Power Equipment

CODE: CC-273

DATE: MARCH 8, 1994

SUBJECT: LIFT ASSIST SPRING CHANGED ON 2000 SERIES TRACTORS (MODELS 2160-2165-2185) SERIAL NUMBERS 242707-244932.

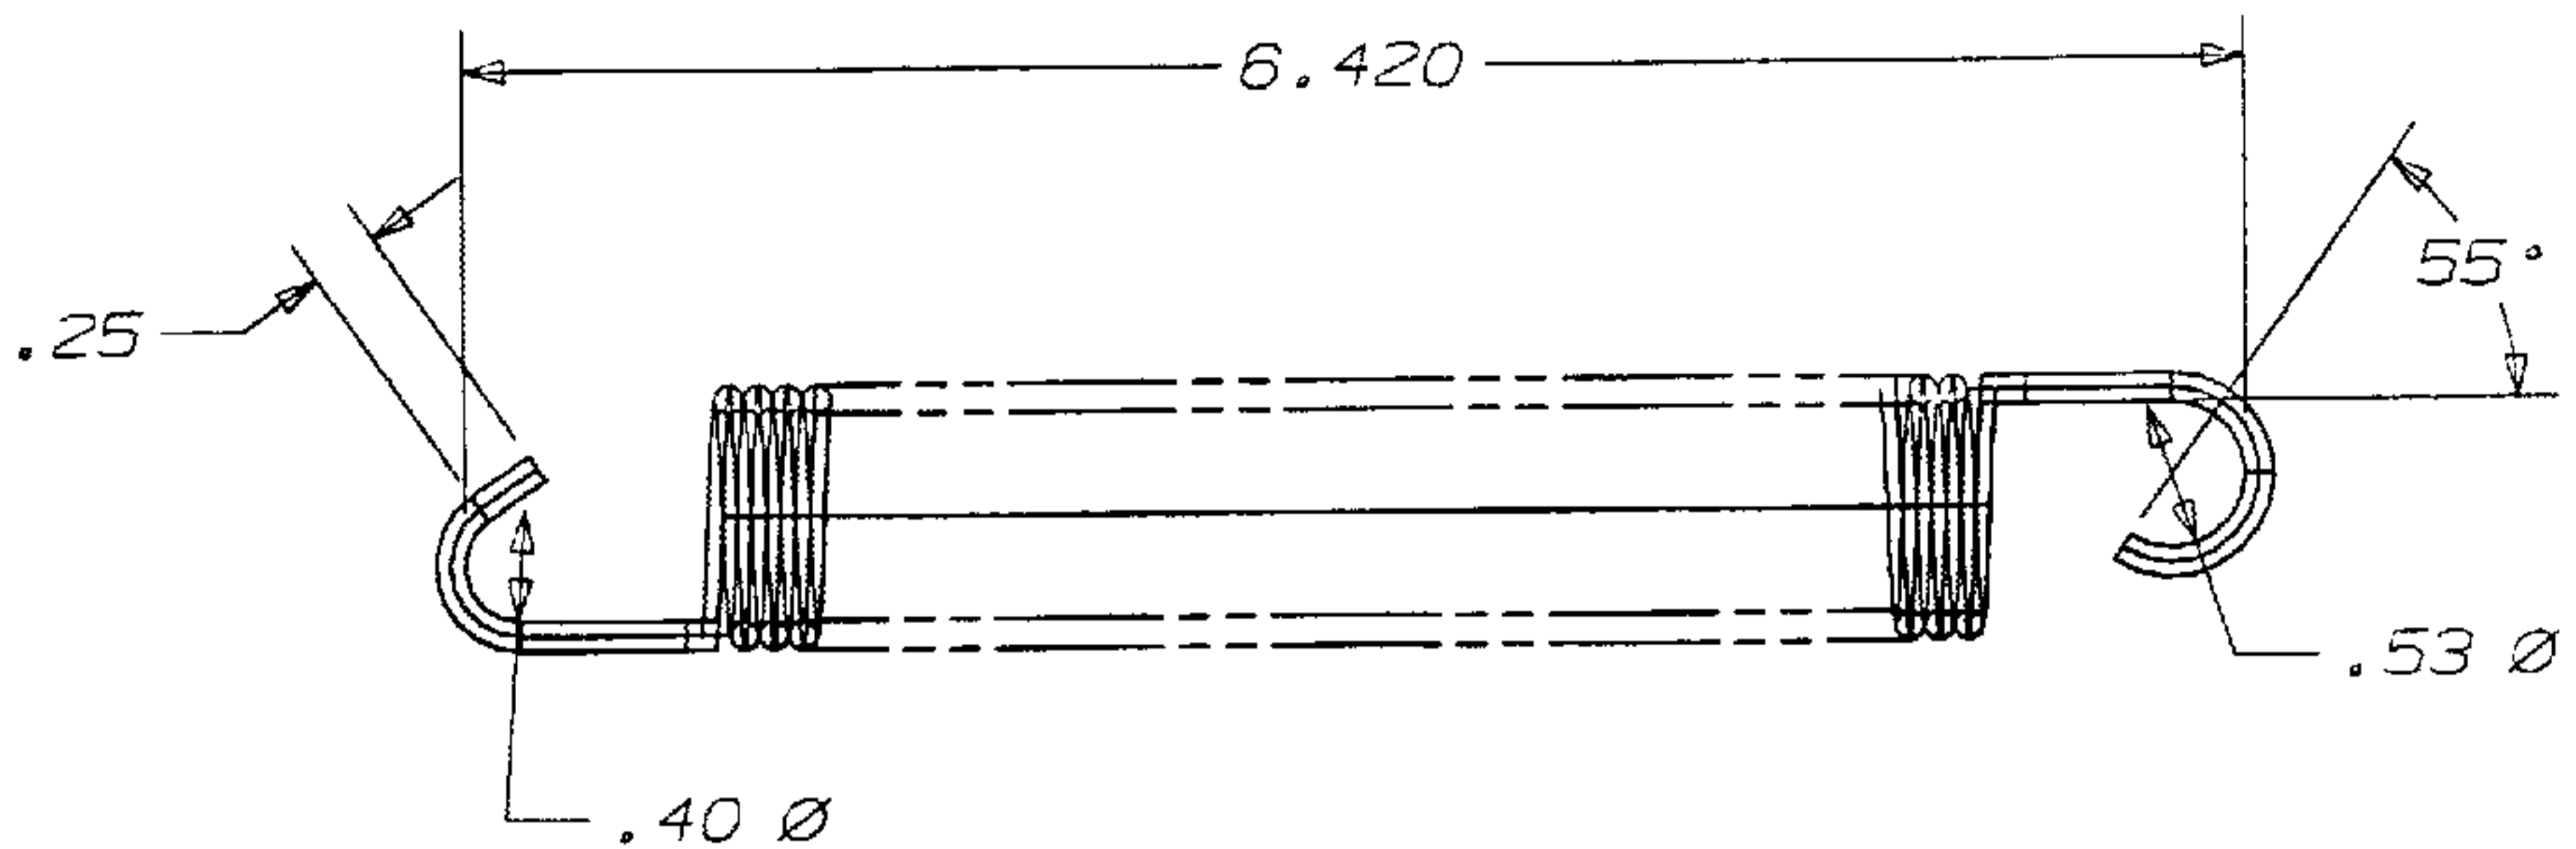
Currently we are using springs that tend to give too much lift assist, which may cause the deck to lift at an improper angle.

To help overcome this problem two new springs have been designed and will be included with the respective mower decks, one with 190-300-100 46" deck and two with 190-301-100 48" deck. All lift assist springs have been removed from the above tractors after the serial number listed above. Mower decks produced after, March 1, 1994, have the springs included with decks. The date code on the mower deck box will read C014G5. To be assured you are using the proper lift assist springs, we suggest the following.

- 1) 190-300-100 46" decks. Remove the lift assist spring from the tractor, 2160-2165-2185, and install a new spring, part number 732-3120A. You will need to order this spring from the part's depot. See page 2 for a discription of this spring.
- 2) 190-301-100 48" decks. Remove the lift assist spring from the tractor, 2160-2165-2185, and the lift assist spring from the mower deck, those decks made BEFORE the date codes listed above. Replace both of these springs with part number springs 732-0594A. Both of the above springs may be obtained from the part's depot. See page 2 for a description of this spring.

SPRING 732-3120A 1.0" O.D. X 6.420 LG. WIRE DIA. .105 43 COILS

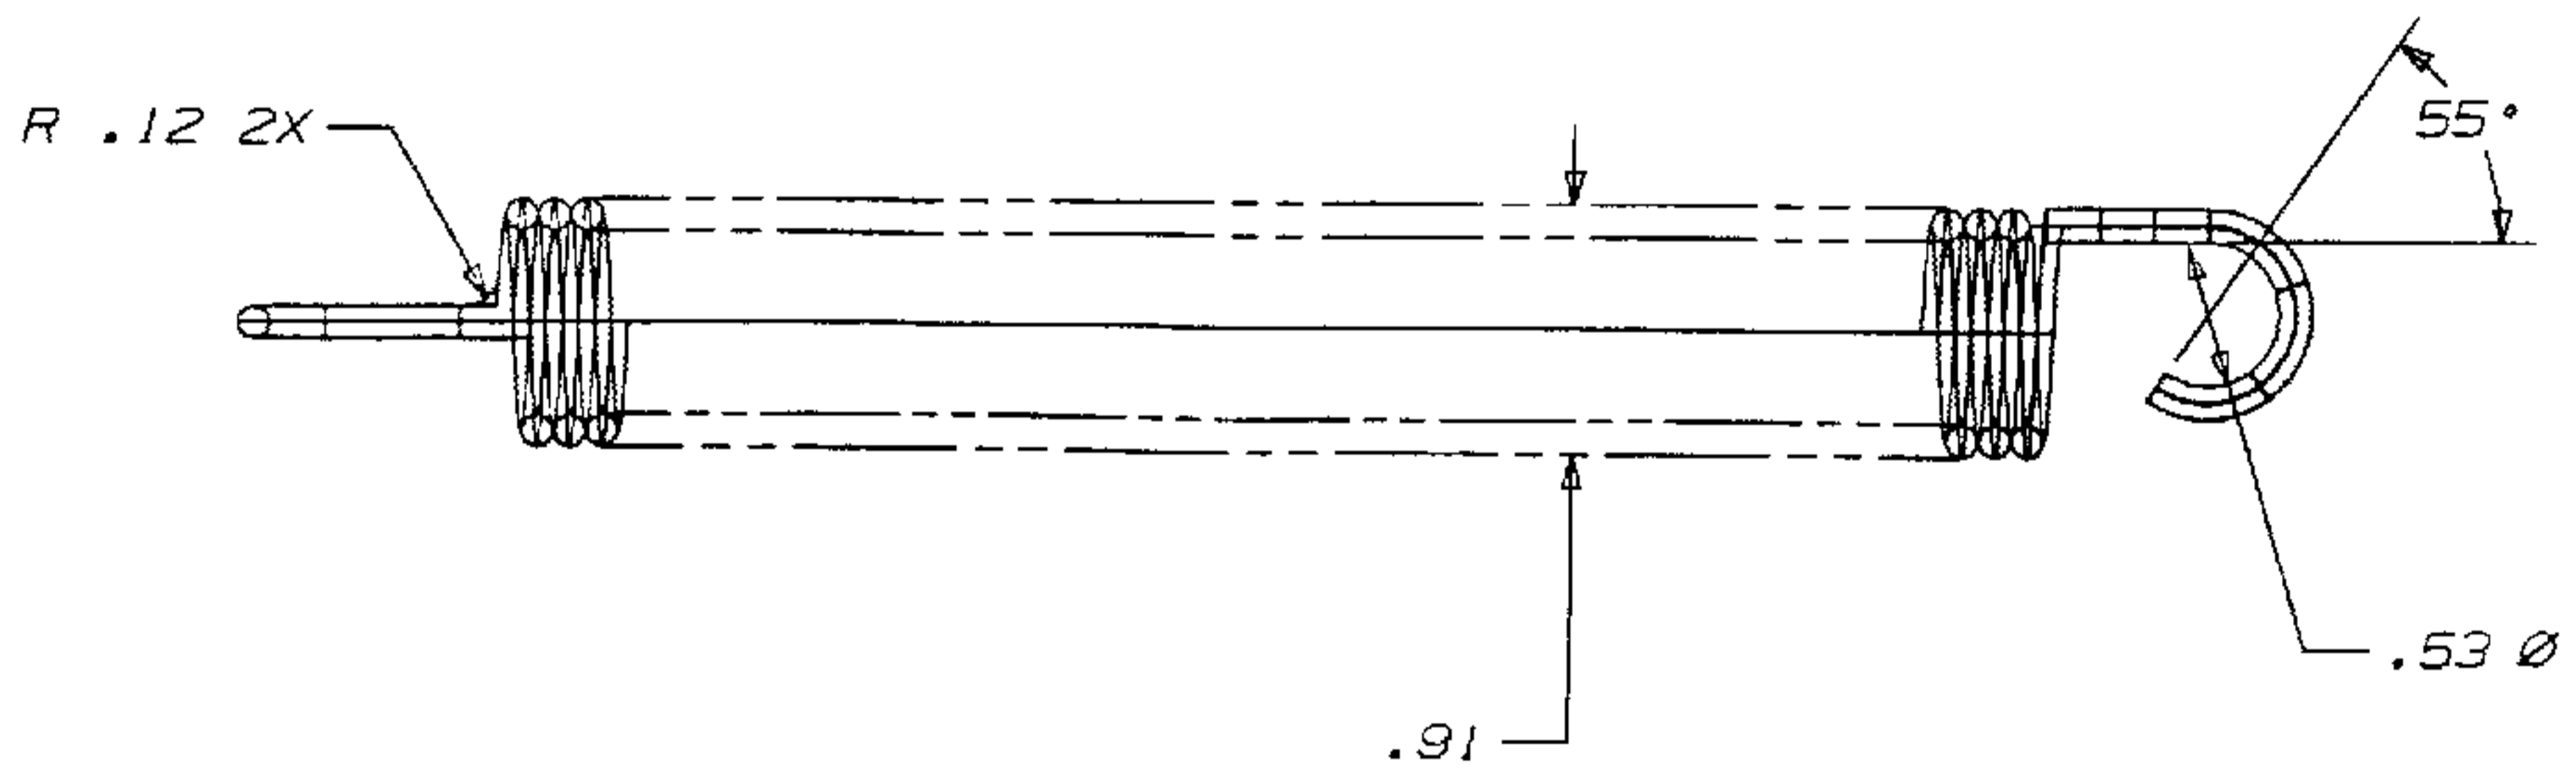
NOTE: In the future, spring 732-0594A will be changed to part no. 732-3126. Until that time use the spring suggested and bend one end as shown in the drawing, before installing spring. The parts book will reflect the new spring part number.

SPRING 732-0594A .91" O.D. X 7.33 LG. WIRE DIA. .120 46 COILS
